Design Changes to the bq24032

PMP Portable Power

This application report discusses the four design changes made to the bq24032 IC and implemented in the bq24032A device.

Figure 1. Charge Termination Currents

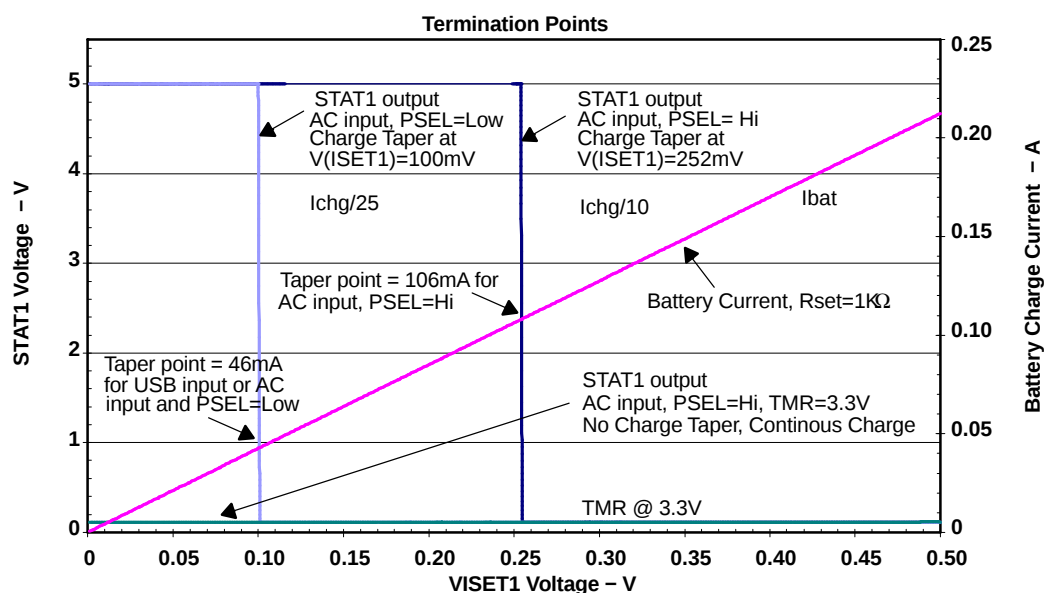
When operating in USB mode and with the ISET2 pin set low, the maximum input current is 100 mA. Early termination occurs in this operating mode if the programmed charge termination current is greater than 100 mA.

If ISET2 is low and USB mode is selected, the actual charging current is limited by the input current regulation; the specification is 80 mA to 100 mA. In this case, battery charging stops when the voltage on the battery exceeds the Recharge Threshold, $V_{rch} = 4.1 \text{ V}$. The Recharge Threshold signal is used internally to prevent charge termination for battery voltages less than V_{rch} .

The design change added a switch to select a lower V_{term} voltage when operating in USB mode. The new V_{term} voltage is typically 100 mV. There are now two termination thresholds: 250 mV or 100 mV. The lower value is selected when in USB mode. The charge termination currents for the new bq24032A, are:

AC input power and PSEL = Hi, Vterm = 250 mV. Iterm = $0.25 \text{ A} \times 425/1 \text{ k}\Omega = 106 \text{ mA}$.

For all other cases, Vterm = 110 mV, Iterm = $0.1 \text{ A} \times 425/1 \text{ k}\Omega = 46.8 \text{ mA}$.

Figure 1 shows the two charge termination thresholds.

Figure 2. bq24032 Device Showing Fault After Normal Charge Cycle

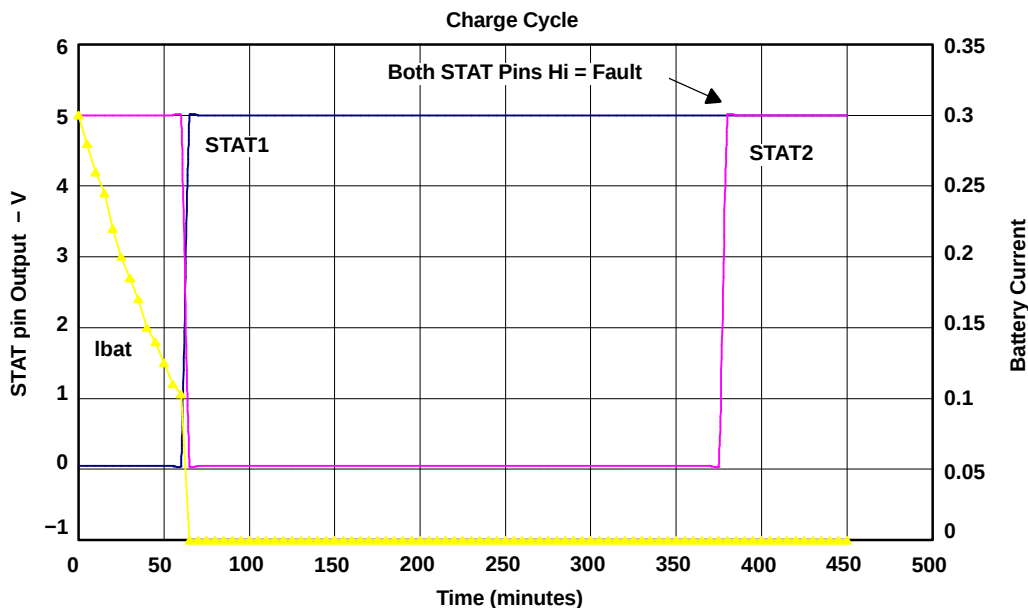
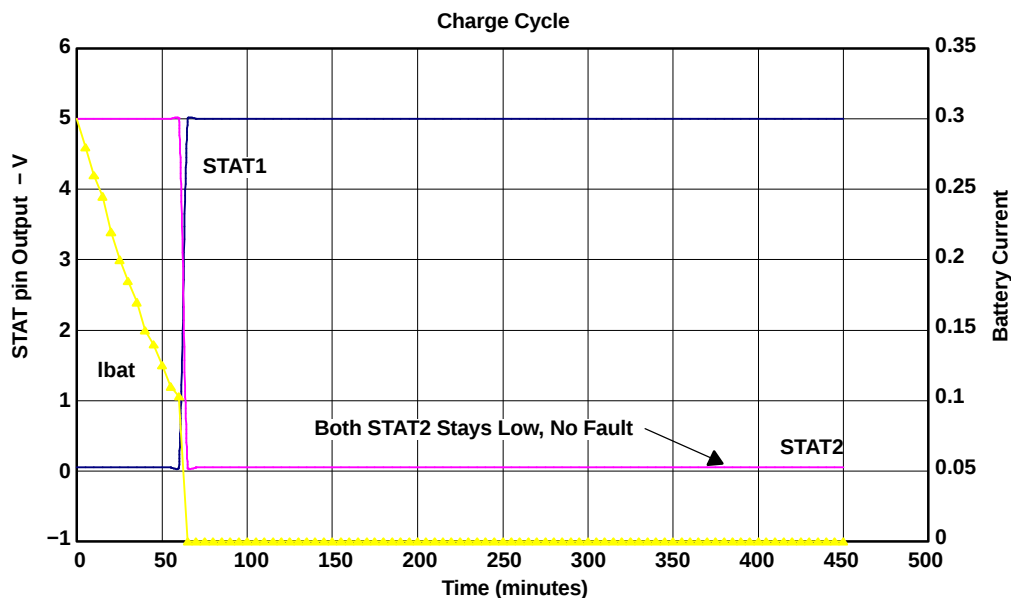
A logic control error in the Charge Control state machine causes a false Charge Safety Timer Fault condition after a normal charge cycle. When a normal charge cycle is completed, the Charge Safety Timer is reset. However, because of the logic error, the Charge Safety Timer starts running again. Therefore, on the bq24032, a Charge Safety Timer Fault condition is indicated at the STAT1 and STAT2 pins one Max Charge Time Period after the completion of a normal charge cycle.

This problem is shown in Figure 2. For this test case, a partially discharged battery was used. The Max Charge Time was set to 5 hours, Rtmr = 50 kΩ. A normal charge cycle is completed at Time = 65 minutes. At Time = 375 minutes, the STAT pins change from indicating Charge Complete (STAT1 = Hi, STAT2 = Low) to Fault (STAT1 = Hi, STAT2 = Hi). The difference in time from Charge Complete to Fault is 375 – 65 = 310 minutes, or approximately 5.2 hours. The Fault state at Time = 375 minutes is the problem and should not occur.

Figure 3 shows the same test with the new bq24032A. No Fault state occurs after a normal charge cycle completes.
